UNITED STATES PATENT AND TRADEMARK OFFICE

APPLICATION NO.	FILING DATE	FIRST NAMED INVENTOR	ATTORNEY DOCKET NO.	CONFIRMATION NO.
10/749,396	01/02/2004	Takeshi Yamamoto	247209US2	2864
22850	7590	01/18/2006	EXAMINER	
OBLON, SPIVAK, MCCLELLAND, MAIER & NEUSTADT, P.C. 1940 DUKE STREET ALEXANDRIA, VA 22314			CHEN, WEN YING PATTY	
			ART UNIT	PAPER NUMBER
			2871

Office Action Summary	Application No. 10/749,396	Applicant(s) YAMAMOTO, TAKESHI	
	Examiner Wen-Ying P. Chen	Art Unit 2871

DETAILED ACTION

FIG. 10

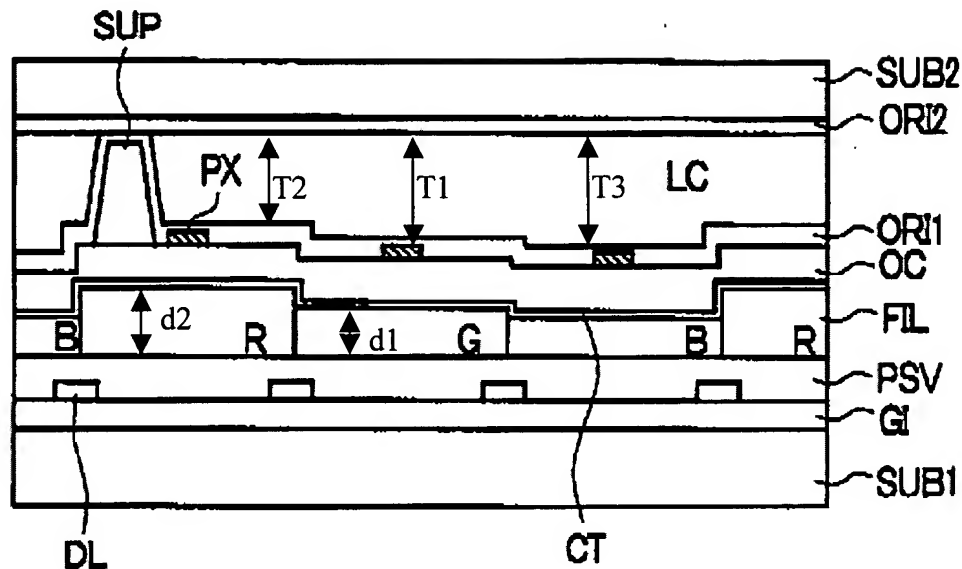
With respect to claim 1 (Amended): Ochiai et al. disclose in Figure 10 a liquid crystal display apparatus comprising:

a plurality of pixels which are disposed in a matrix (Column 8, lines 12-15), the pixels including a first pixel with a first gap (element T1 as indicated in the figure below) for interposition of the liquid crystal layer (element LC) between the first substrate (element SUB1) and the second substrate (element SUB2), and a second pixel with a second gap (element T2 as indicated in the figure below) that is smaller than the first gap, the first pixel including a first color filter layer that has a first film thickness and mainly passes first color light, and the second pixel including a second color filter layer that has a second film thickness, which is greater than the first film thickness, and mainly passes second color light; and a columnar spacer (element SUP) for creating the second gap, the columnar spacer being disposed not at the first pixel but at the second color filter layer at the second pixel.

Ochiai et al. fail to disclose that the first color filter passes the first color light having a wavelength that is greater than a wavelength of the second color light.

As to claim 8: Ochiai et al. further disclose in Figure 10 that the plurality of pixels further include a third pixel with a third gap (element T3) that is greater than the first gap (element T1).
